**Expanded from November 23, 2020
Public Comment at Conservation Commission Meeting**

Colonial Durham Associates' (CDA's)
“Alleged Outcroppings”

December 3, 2020

SUMMARY OF FLOWS DISCHARGING TO COLLEGE BROOK

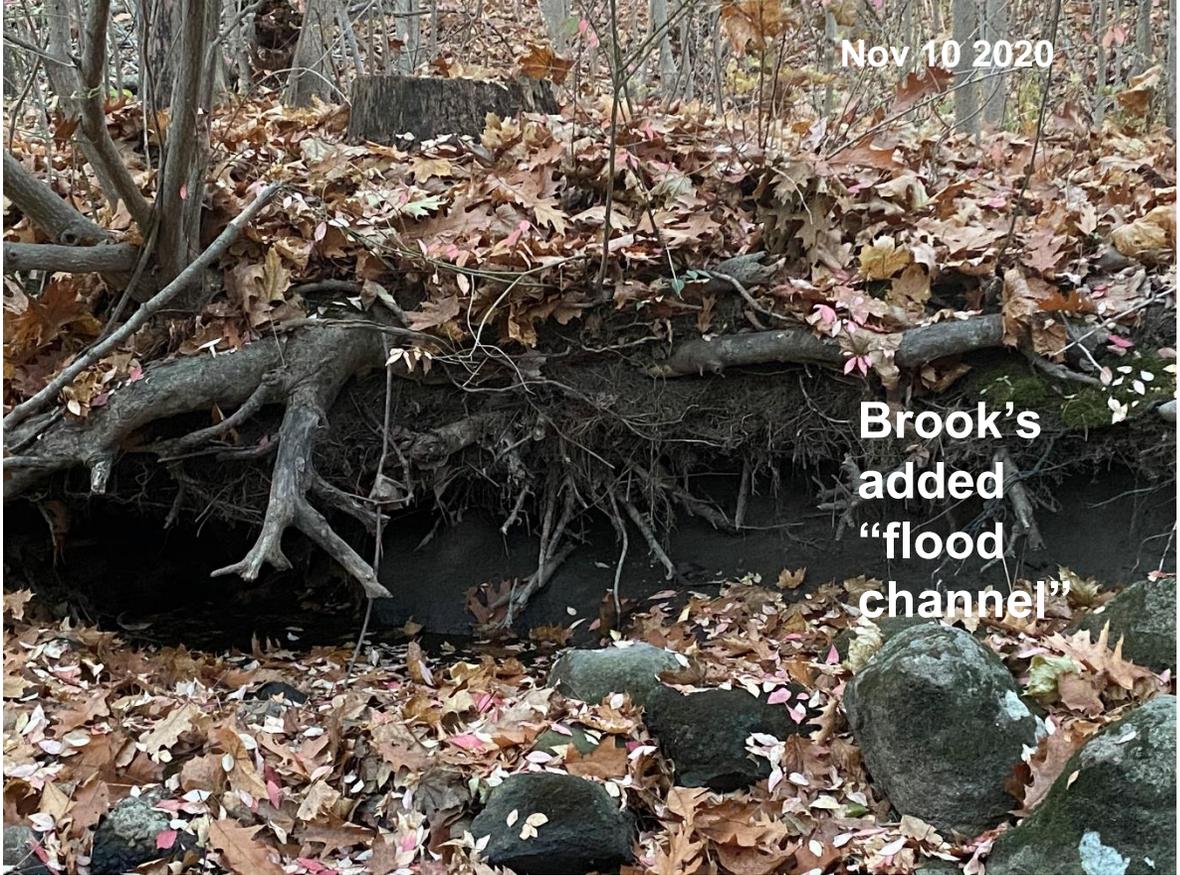
Even by CDA's own projections, "Post-Development Flow Reductions" drop to almost nothing* by the time a "100-year" (really annual) storm would occur. Any larger storm would likely overwhelm the system, **INCREASING flooding** – *unless pervious areas were increased (along Brook) and spared (acre+ hillside).*

*Not only is claimed reduction a *projection*, subject to a margin of error in calculation, but the 6% reduction is calculated from the POST-2002 *increase* in flooding from the illegal 9,000sf hillside bulldozing, rather than from the most-recent *legal* "existing condition," pre-2002. Note also that an "increased natural buffer...adjacent to the College Brook" is a requirement of the 2015 legal Settlement.

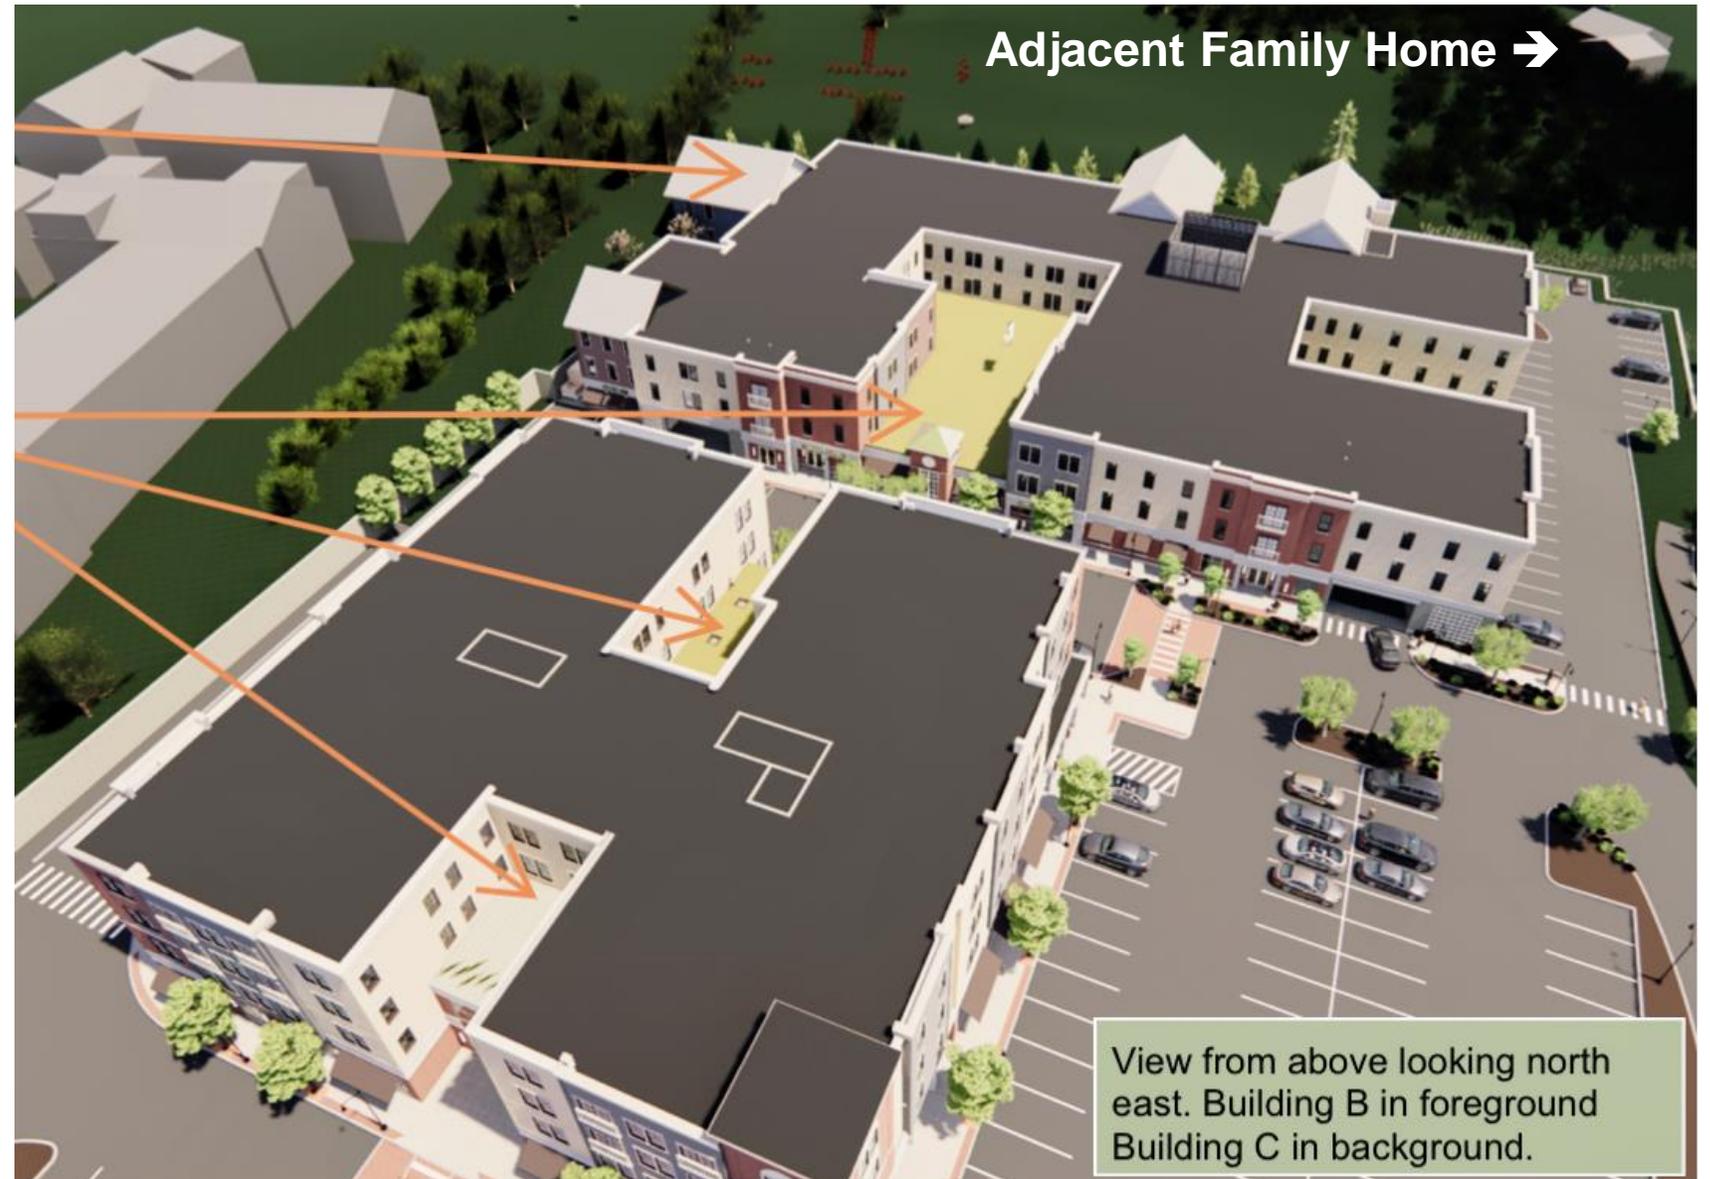
ALLEGED: the site plan is “consistent with the existing condition” [*thus, allegedly exempt from CU review*]

Reality: [Taintor Email 10-23-20](#) “I don’t believe that *any* of the proposed redevelopment within the wetland buffer, including the parking lot, is exempt from compliance with the zoning, because (a) new underground utilities and infrastructure are proposed in existing paved areas, and (b) there will be extensive changes in grade throughout – some areas within the wetland buffer are proposed to be raised or lowered by up to at least 3 feet in elevation. As a result, **all the items listed on pages 2 and 3 of my [report](#) require conditional use approval.**” (emphases & link added)

ALLEGED: CDA proposed structures “cannot be located elsewhere without altering the configuration and layout of the proposed buildings and use densities”

Circular Reasoning: CDA “needs” to infringe on setbacks because it does not want to make its massive proposed buildings smaller. ***That is, CDA wants to do what it want to do.***

NOTE: Mislabeled by CDA as “looking North East” (where 2015 legal Settlement says housing should be located); actually looking SOUTH East.

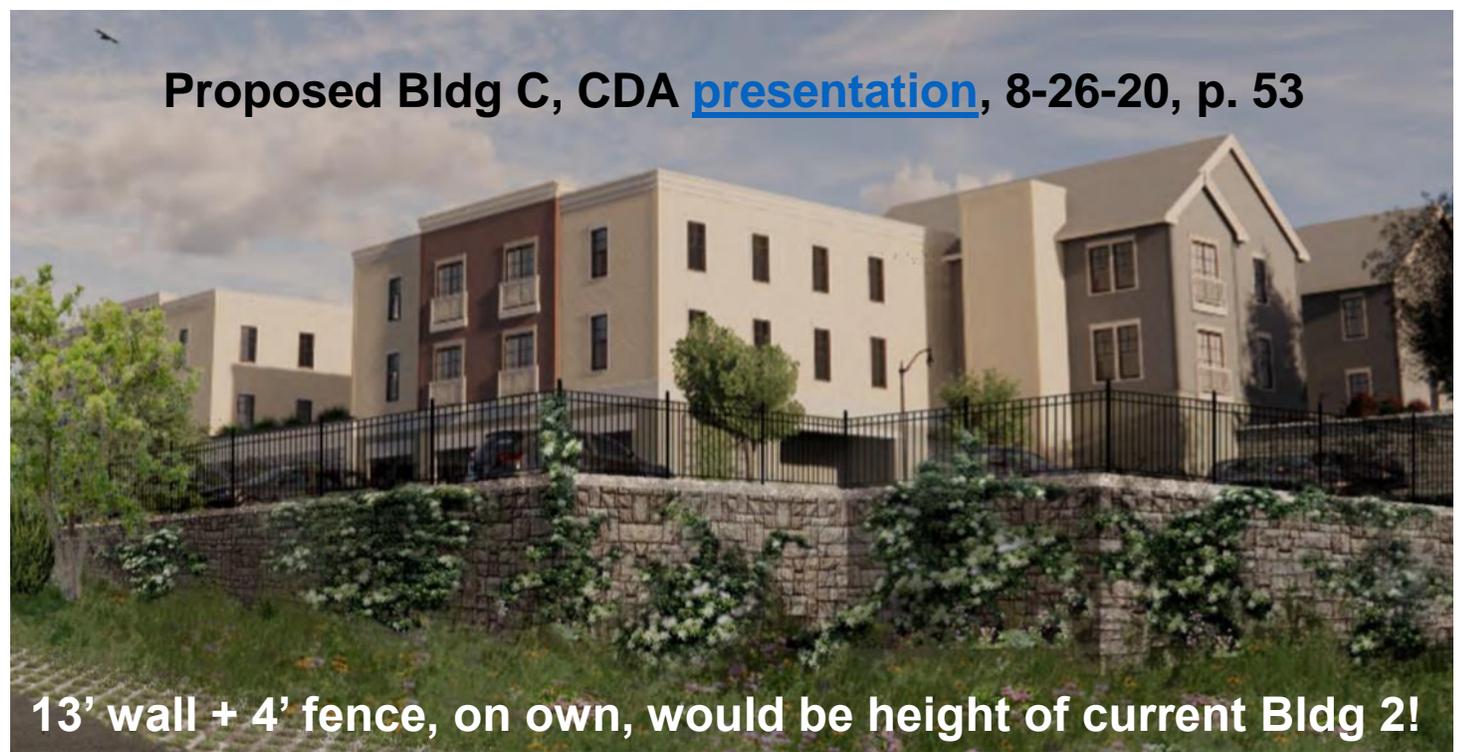
Top right: Bldg C would be 4 times taller & 150' closer to wetland & to neighborhood than currently prominent Bldg 2.

Bottom right: CDA's Alleged Illustration of completed project as it would supposedly appear from adjacent neighborhood.

CDA “disappears” massive structure into Disneyfied magic forest.

CDA insults intelligence of Durham boards and public with absurd, illusionary images.

In CDA [presentation](#), 11-18-20, p. 14, Bldg C “disappears”

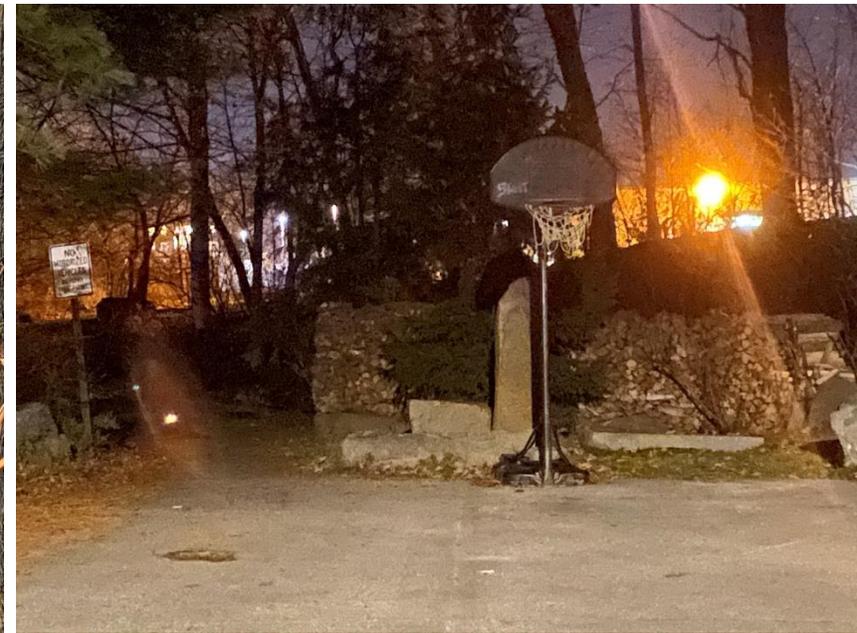
Current Reality (top) vs. CDA Illusion (below).

CDA's "winter forest" displays **mulched brook bank & wetland**. In reality, brook & bank have routinely flooded downstream of Plaza since 2002, killing many trees and plants.

[Site Plan Rendering 1-2-20](#)

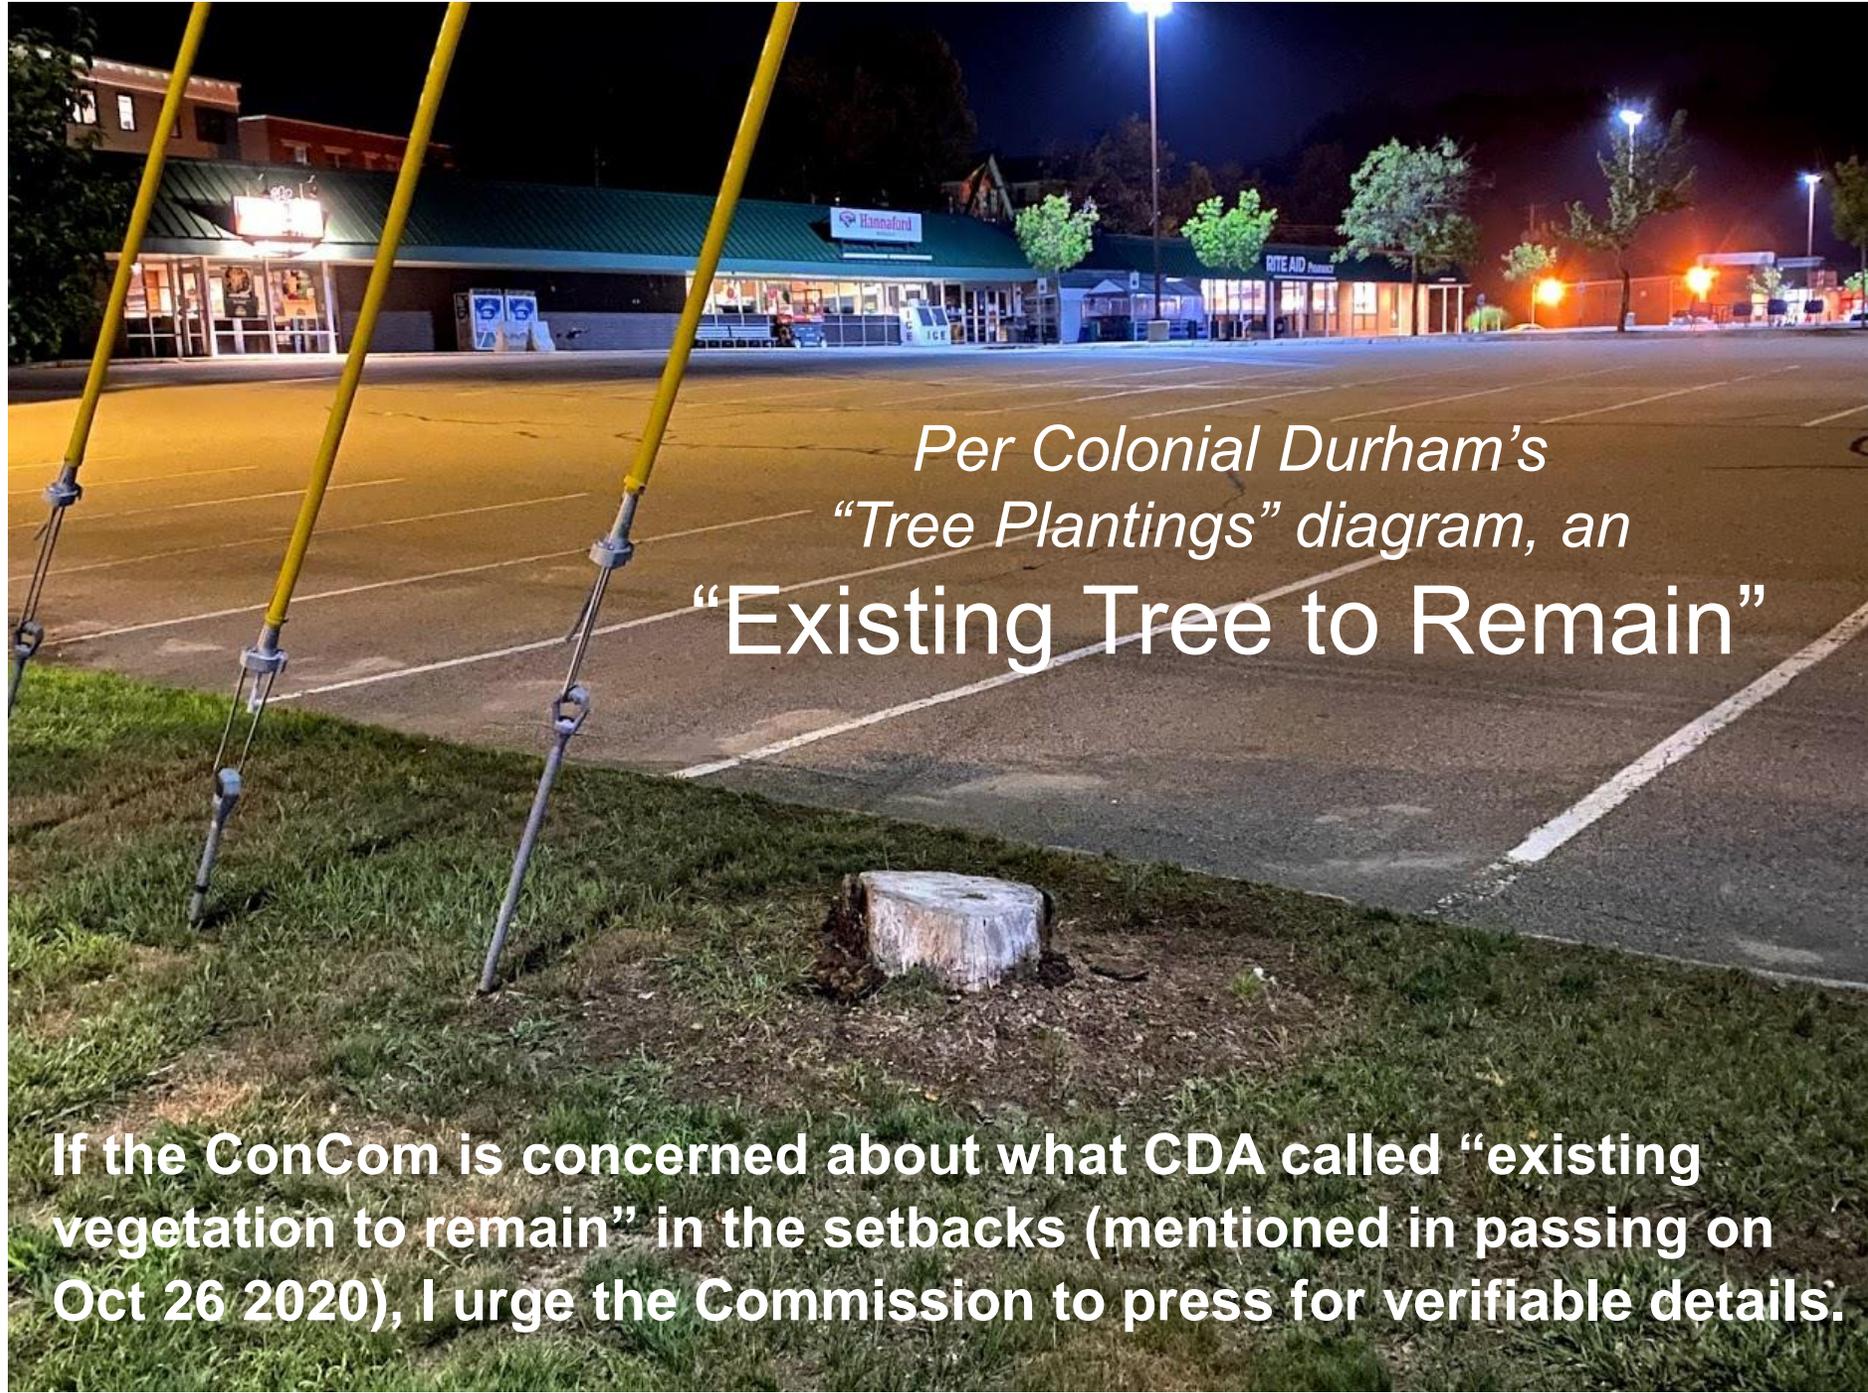
Town Boards should look beyond smoke & mirror obfuscations to consider the full impacts of *both* of these inter-connected applications, in combination, with *major deforestation upland of College Brook*.

*Per Colonial Durham's
"Tree Plantings" diagram, an
"Existing Tree to Remain"*

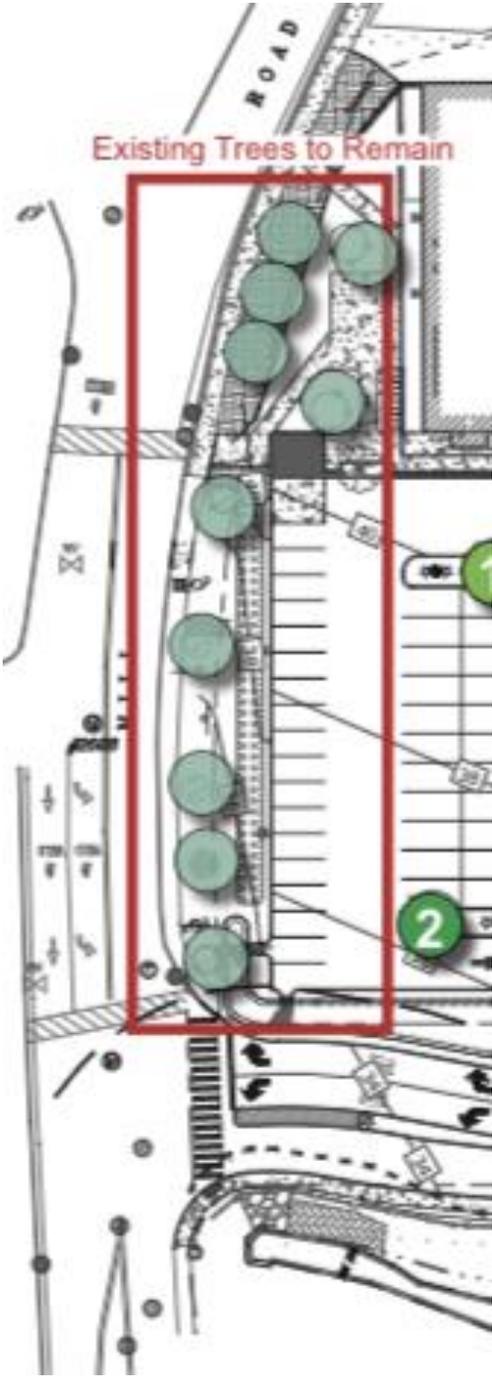
If the ConCom is concerned about what CDA called "existing vegetation to remain" in the setbacks (mentioned in passing on Oct 26 2020), I urge the Commission to press for verifiable details.
